# RIVERSIDE STATION APARTMENTS

RECEIVED  
 05/03/2022  
 CITY OF MONROE

SPR2022-01  
 #8571

COVER SHEET AND PROJECT OVERVIEW  
 PROJECT NO: 2021-126  
 DATE: DECEMBER 28, 2021

UTILITY PLAN  
PROJECT NO: 2021-126  
DATE: DECEMBER 28, 2021

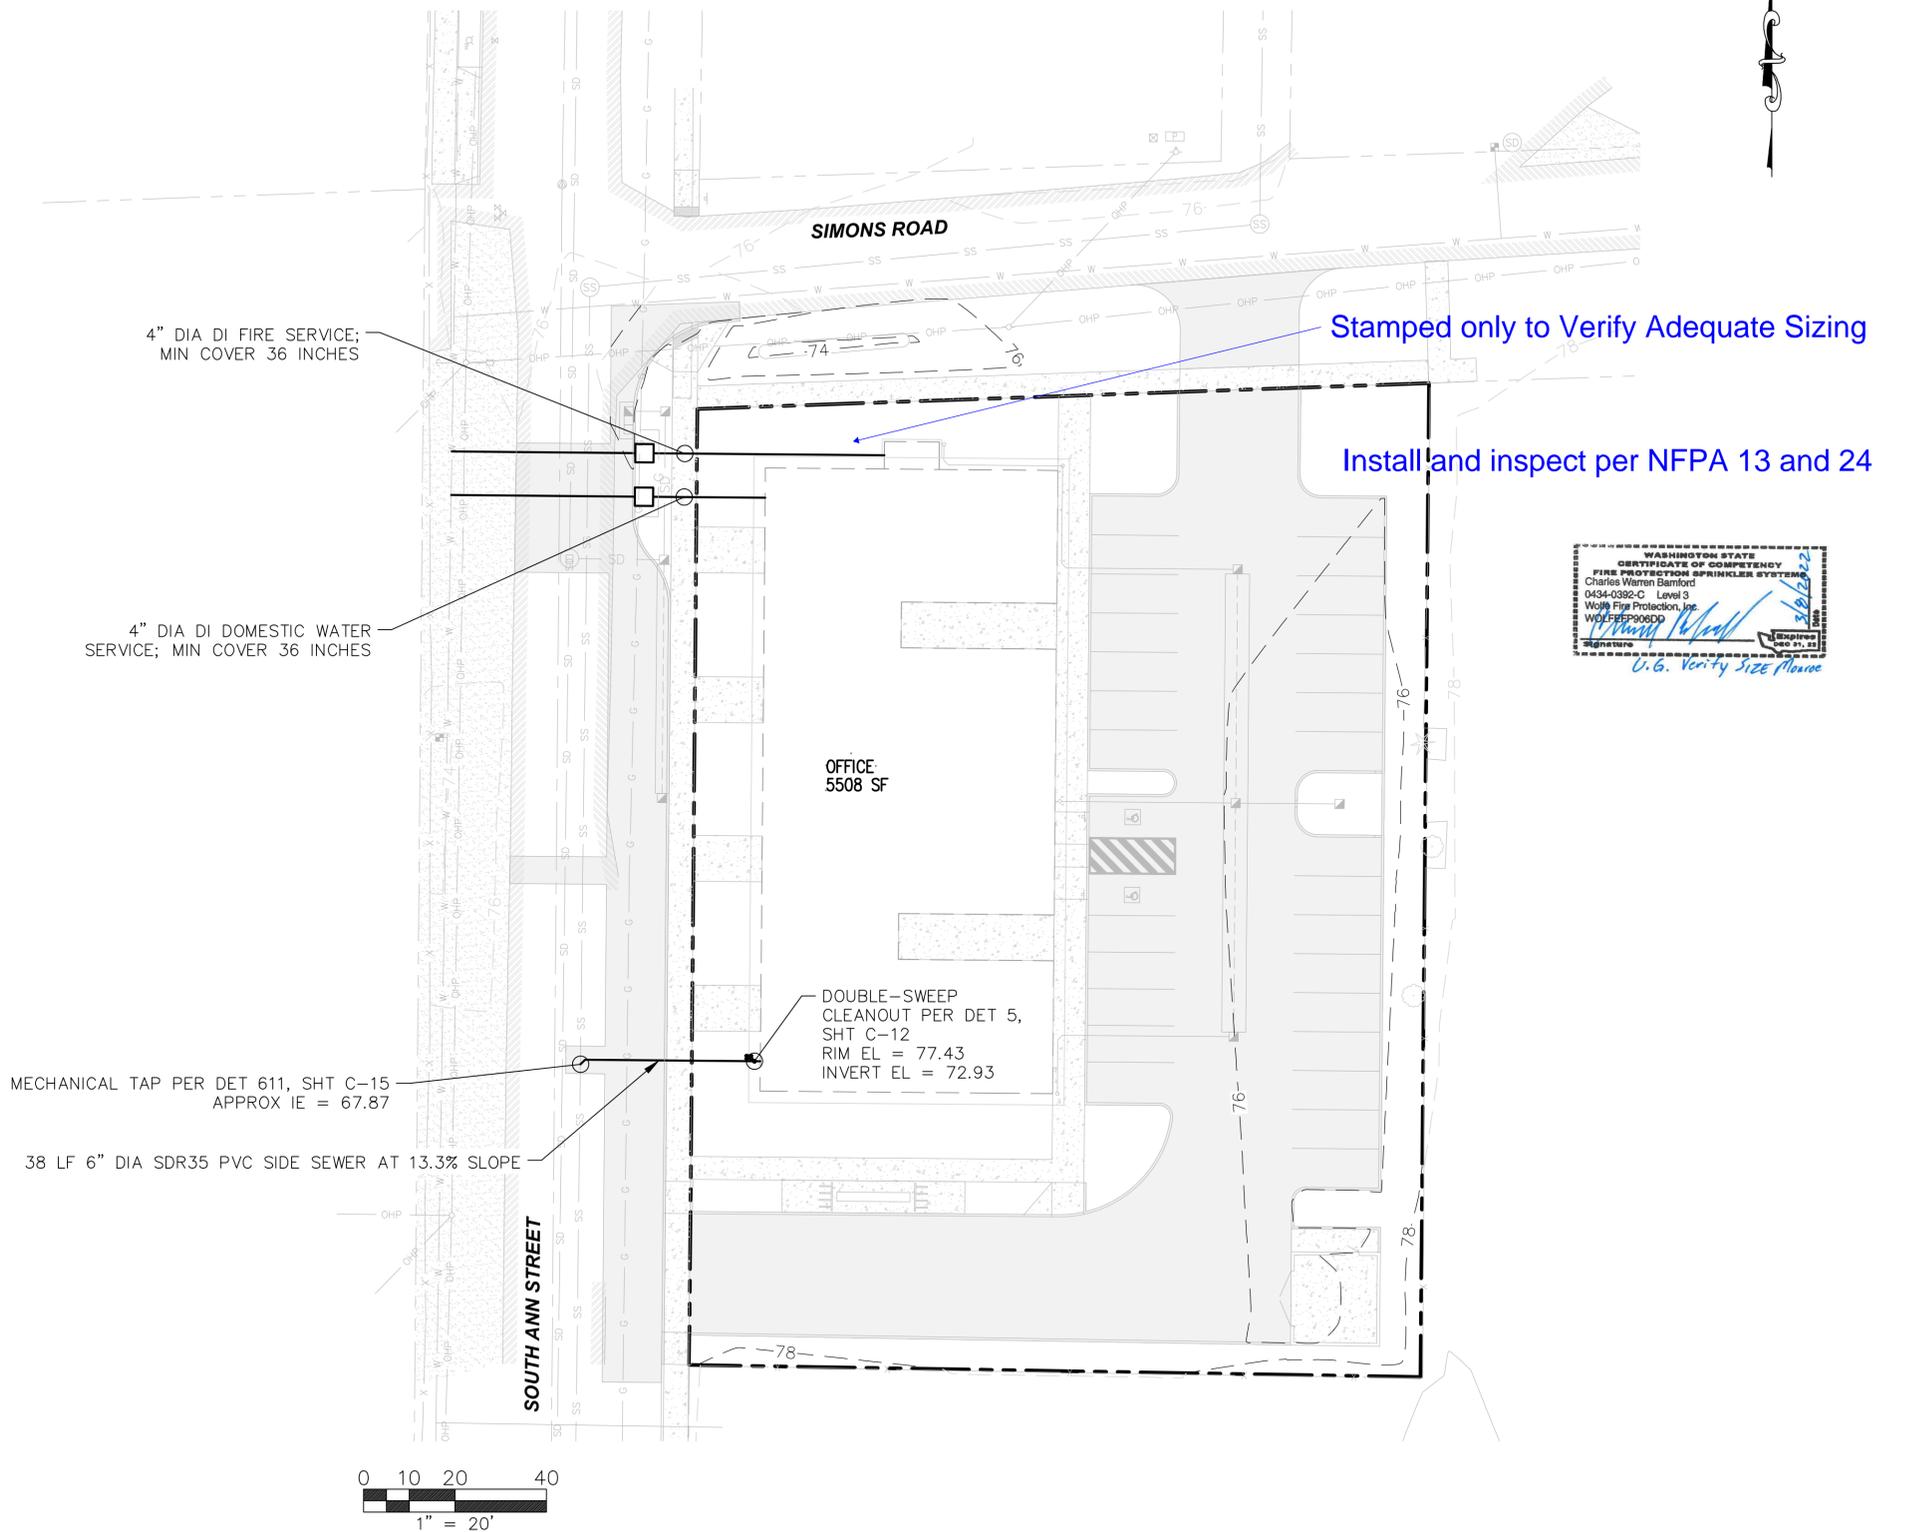
What size service line and meter? Read #1 and #2 above.

A 3-INCH TAP AND METER WOULD COST \$185,072 JUST IN IMPACT FEES SINCE THIS IS A MIXED USE BLDG. AND NO WHERE NEAR THAT CAPACITY IS NEEDED. RECOMMEND A 2-INCH OR 1-1/2-INCH METER. FINAL DETERMINATION BASED ON PLUMBING FIXTURE UNIT COUNT FOR THE BLDG. BUT EITHER ONE WILL HAVE A 2-INCH PIPE FROM THE MAIN TO THE METER. THE ADJACENT RIVERS EDGE APT'S HAD A 2-INCH METER FOR EACH BLDG. WITH 24 APTS/BLDG.

SOUTH ANN STREET IMPROVEMENTS  
 PROJECT NO: 2021-126  
 DATE: DECEMBER 28, 2021

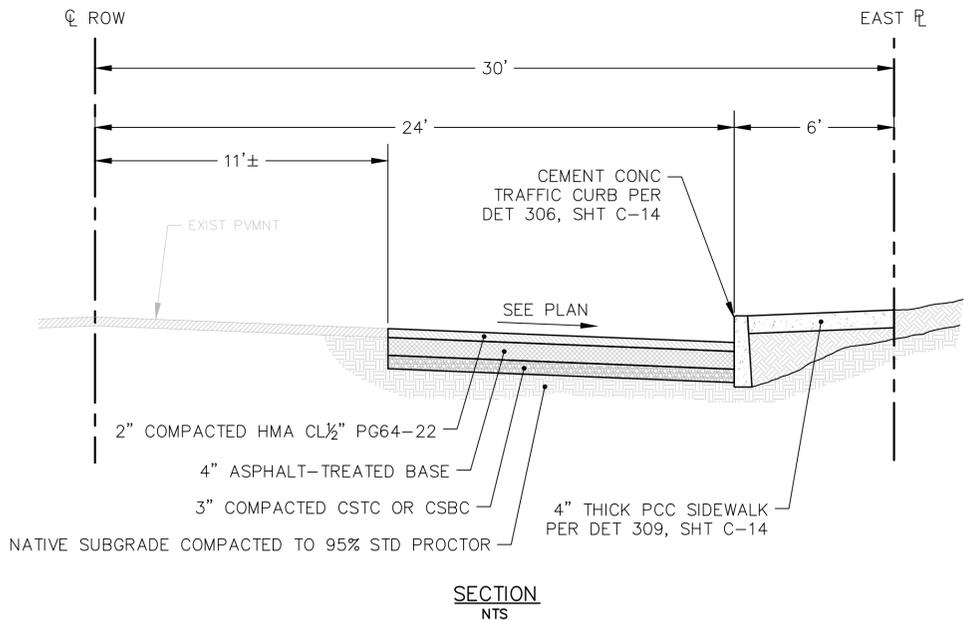
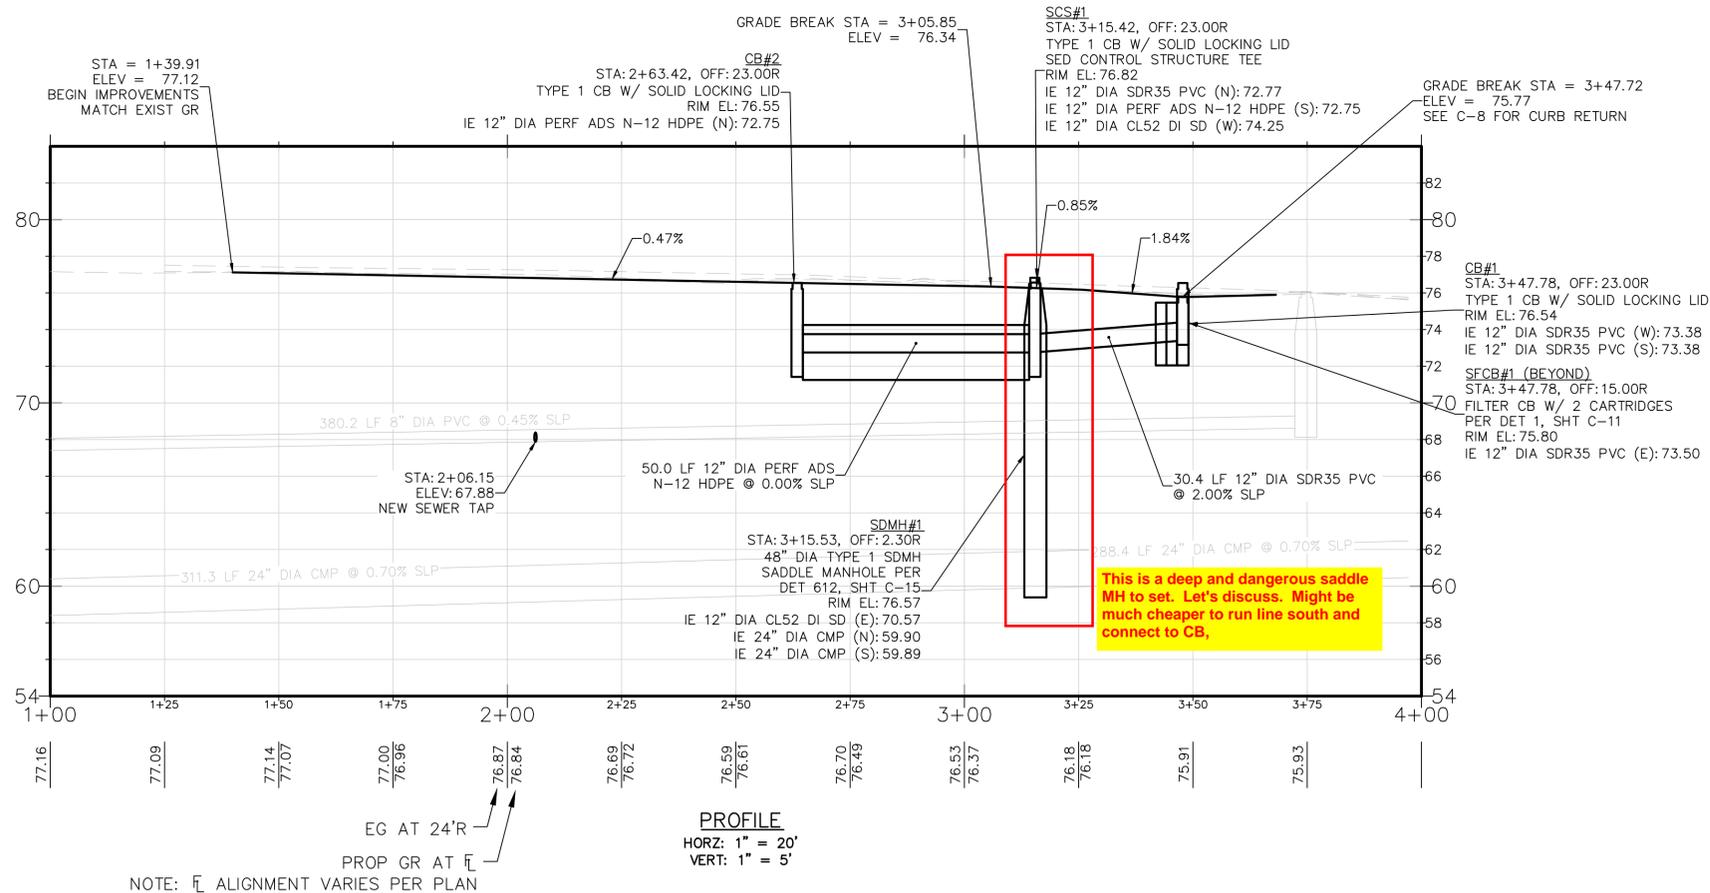
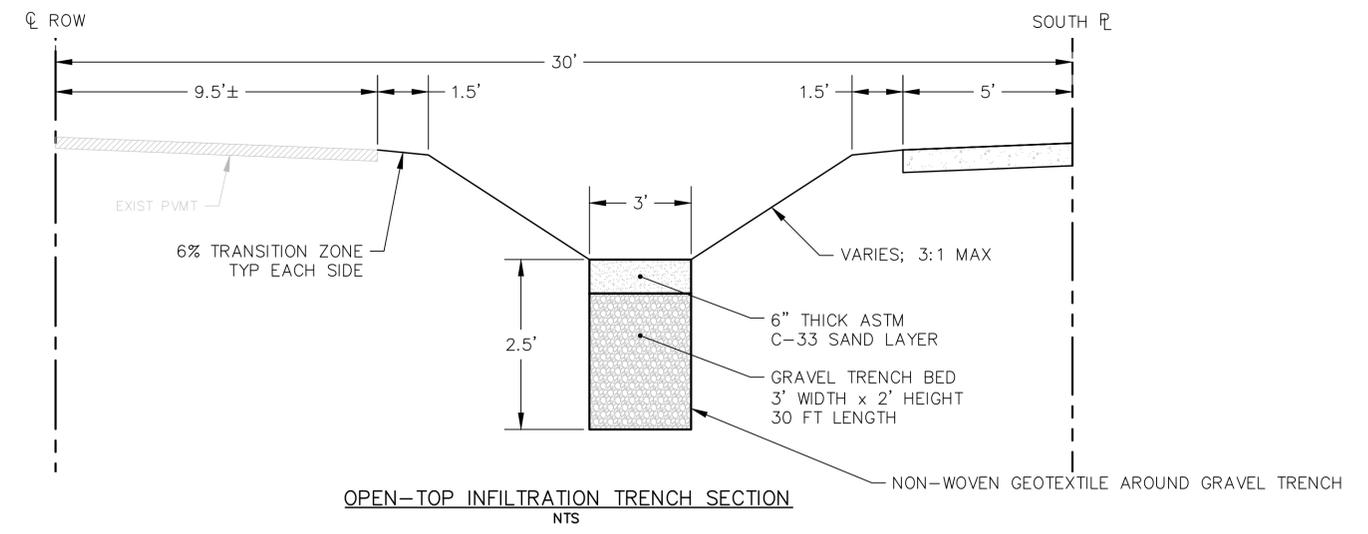
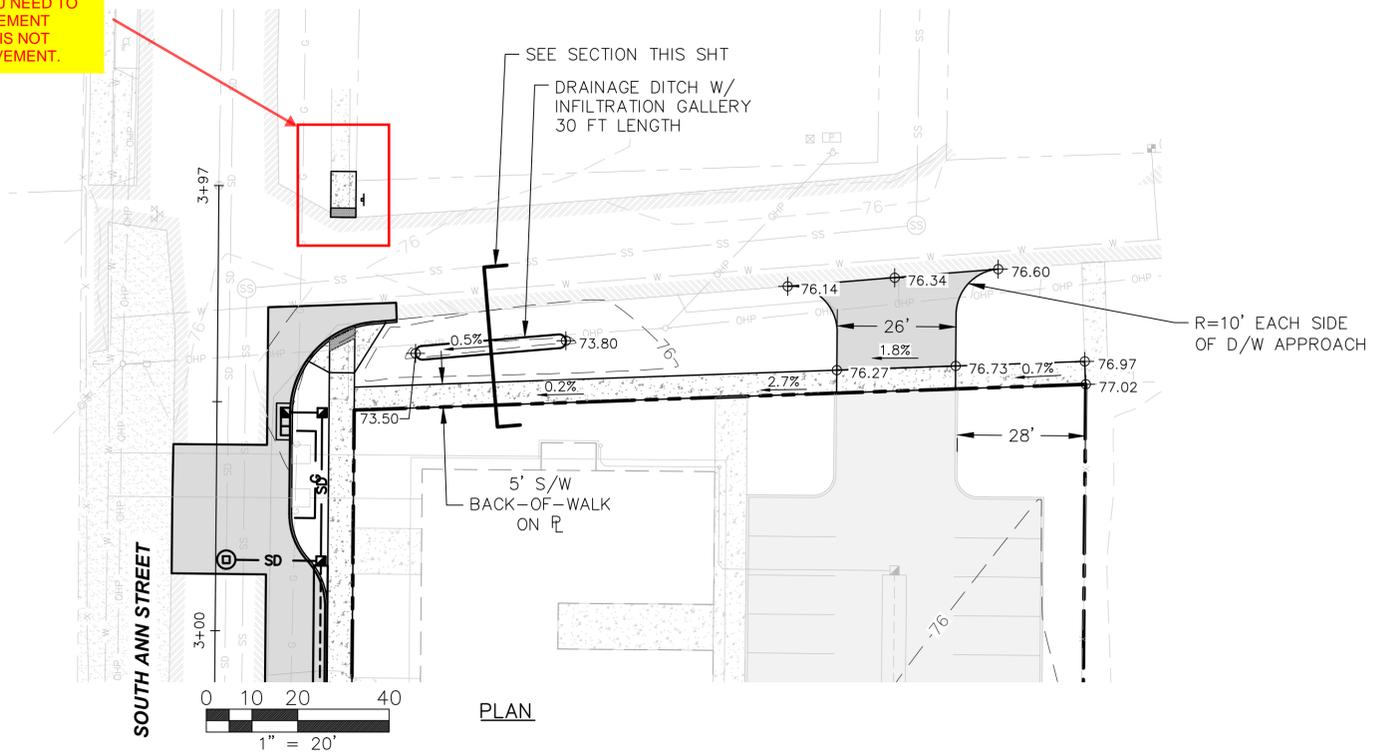
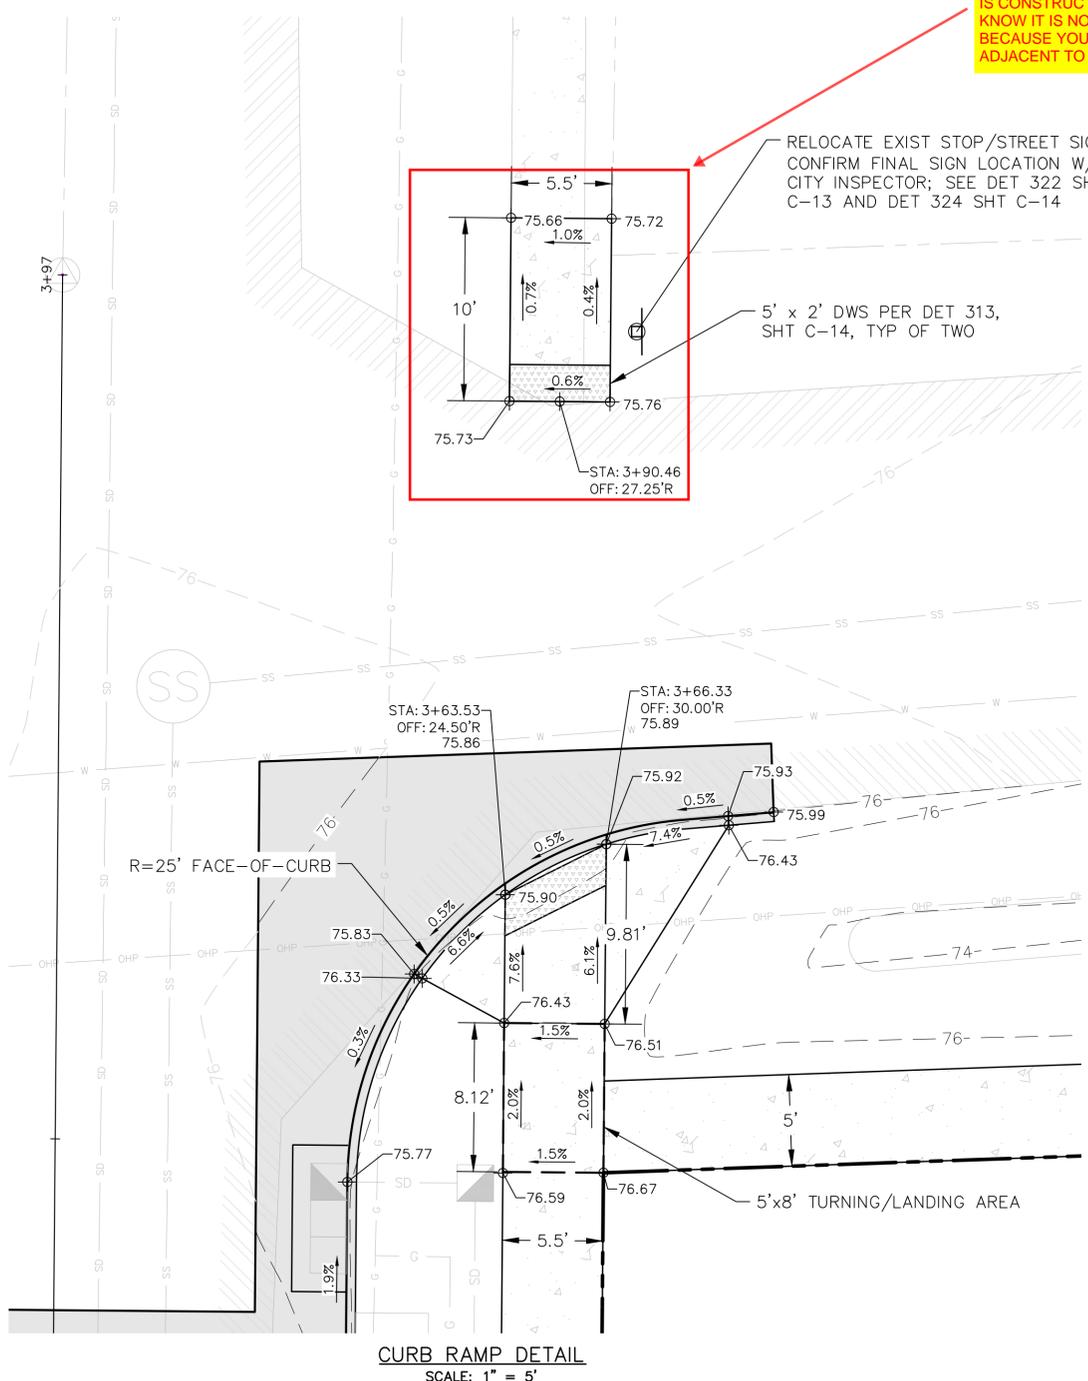
Depending on final sizes of patches this entire area in the red box may be a "Grind & Overlay."

This is a deep and dangerous saddle MH to set. Let's discuss. Might be much cheaper to run line south and connect to CB.

SIMONS ROAD IMPROVEMENTS

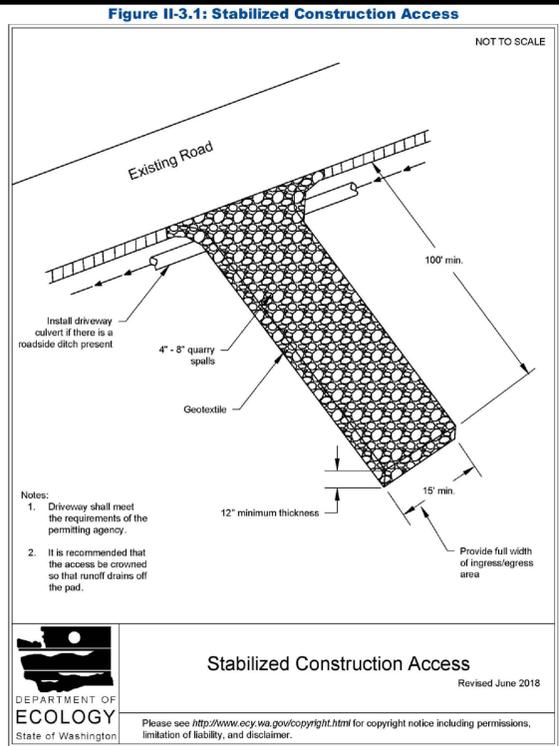
IT IS NICE THAT THIS IS SHOWN ON THE PLANS AND IT WOULD BE GREAT IF IT IS CONSTRUCTED BUT YOU NEED TO KNOW IT IS NOT A REQUIREMENT BECAUSE YOUR PROJECT IS NOT ADJACENT TO THE IMPROVEMENT.

**STREET AND UTILITY DETAILS - 1**  
 PROJECT NO: 2021-126  
 DATE: DECEMBER 28, 2021

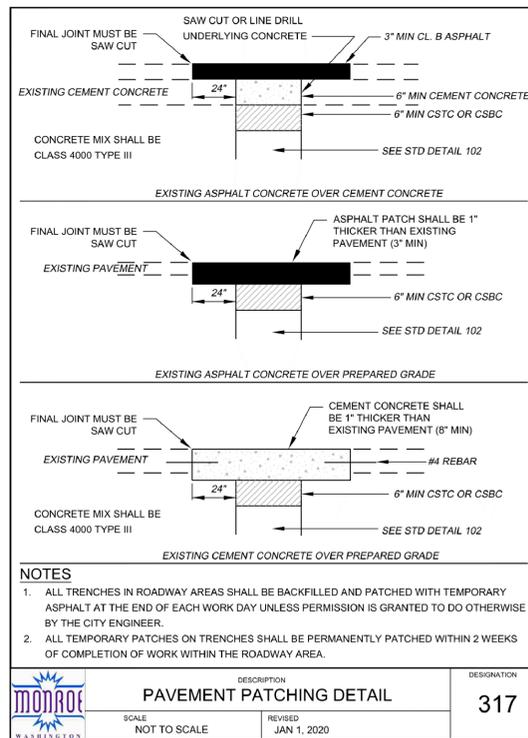
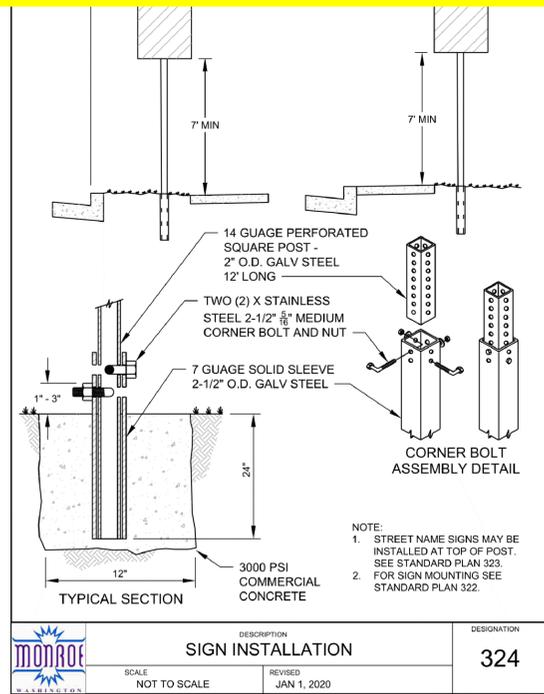
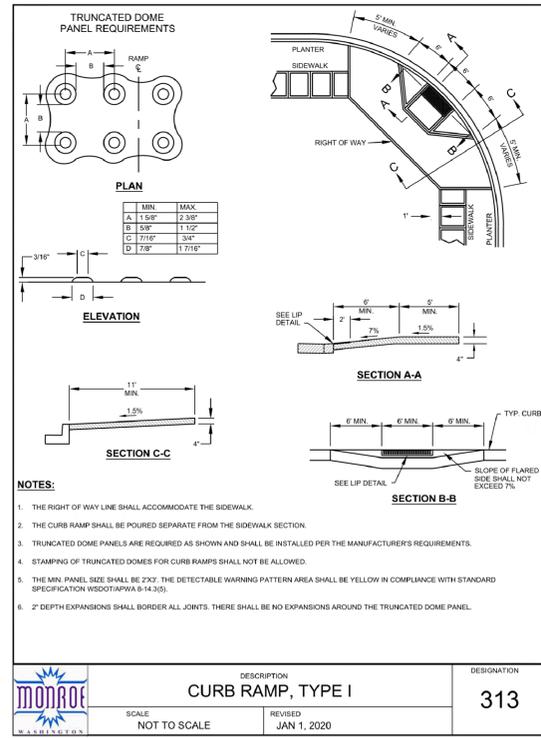
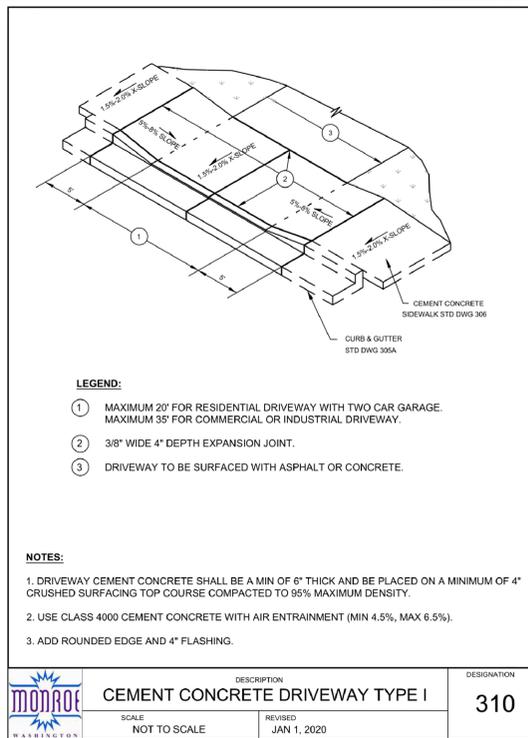
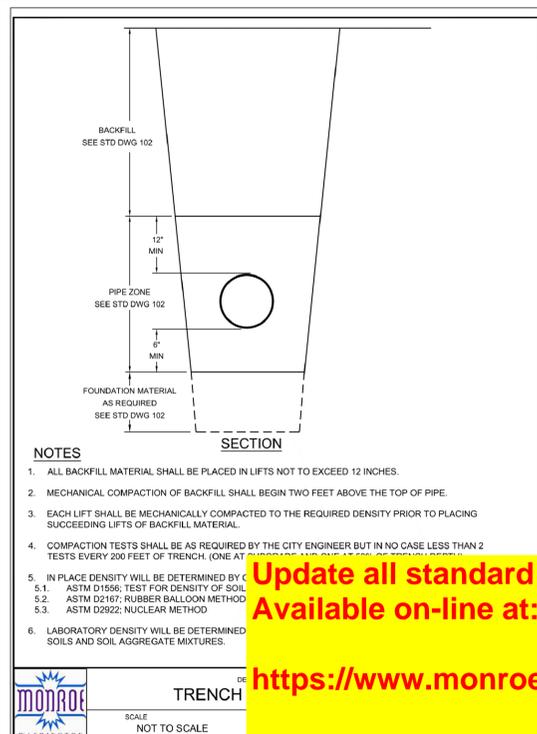
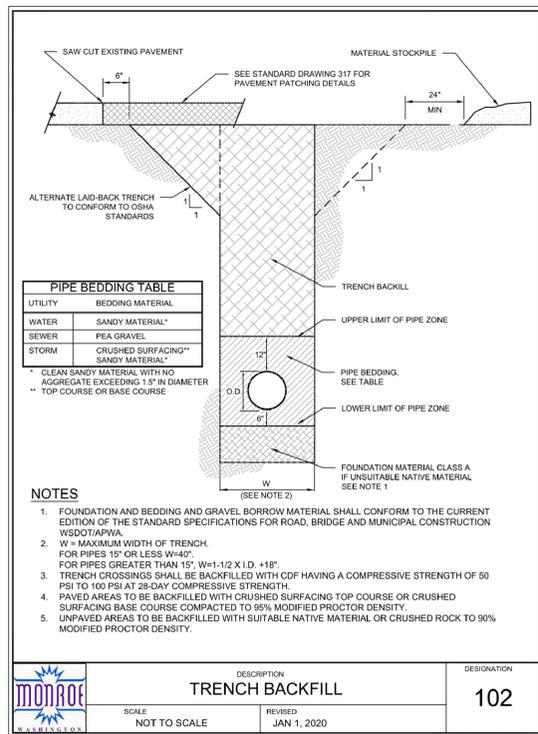
**Update all standard details to the latest version. Available on-line at:**  
<https://www.monroewa.gov/standards>
